Response to Comments

**MTCA stage: Remedial Investigation
and Feasibility Study**

**Industrial Container Services LLC
Cleanup Site
Seattle, WA**

Washington State Department of Ecology

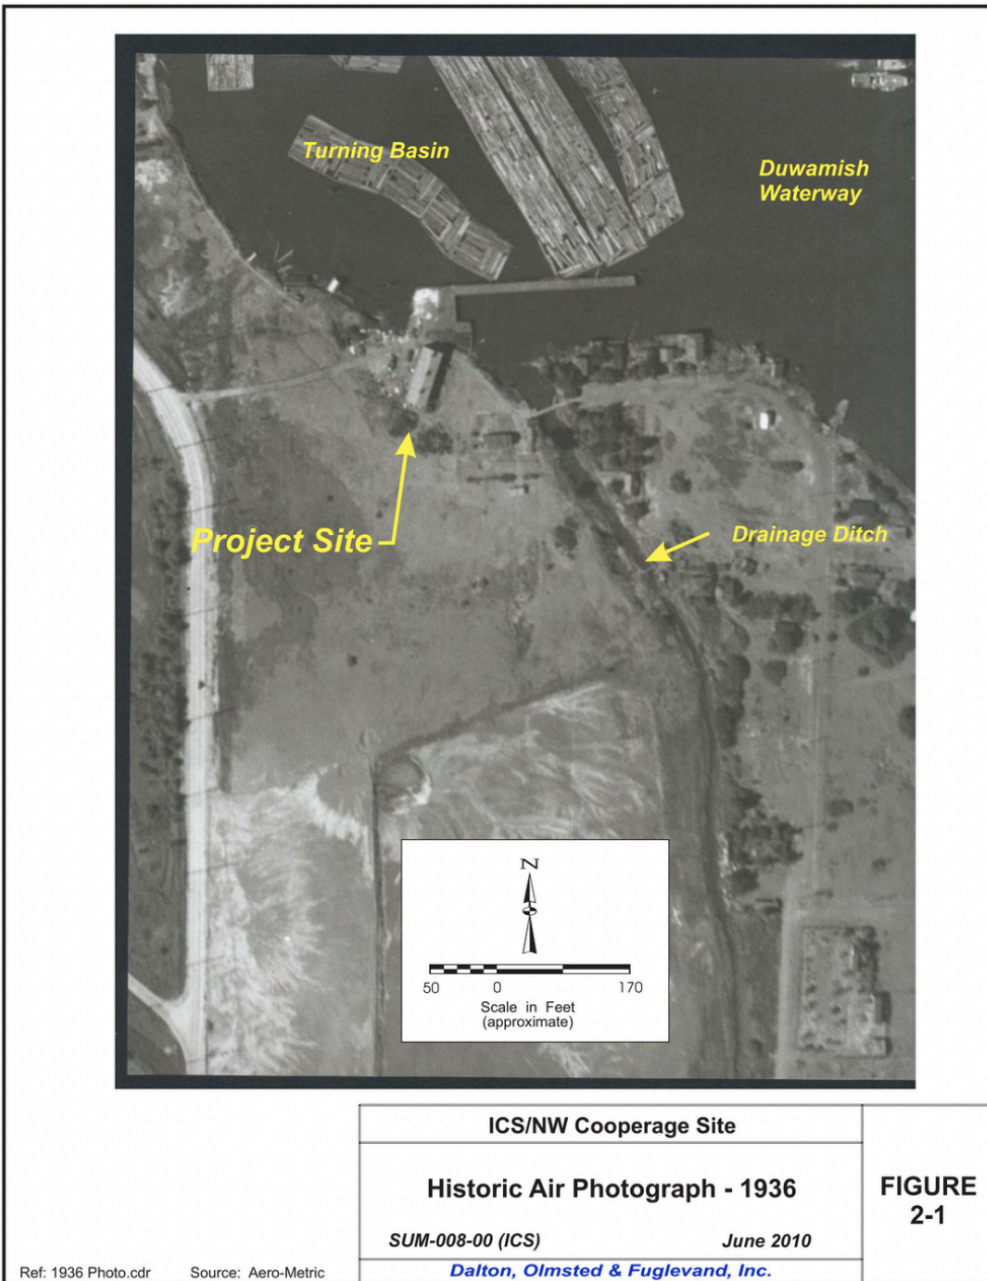
9. Address potential contributions of the former ditch

A surficial drainage ditch occupied the property until it was filled in the late 1960s (shown in Figure 2-1). A portion of this ditch was used as a wastewater settling lagoon. The filled-in ditch now flows in a buried storm water drainage pipe to the 2nd Avenue Outfall.

As noted in the RI/FS the samples from wells near the former drainage ditch had estuarine water contributions that ranged between 49% and 87%. This suggests a high degree of exchange between the river and the former drainage ditch soils and groundwater.

A portion of the filled in drainage ditch was formerly used as a settling basin. Buried sediments in the bottom of ditch are contaminated. The preferred remedial alternative for the area includes excavation of the contaminated sediments to a practical extent. The remedy is supported by an approach of downgradient groundwater monitoring and a contingency plan if the remedy does not control sources of contamination to the LDW.
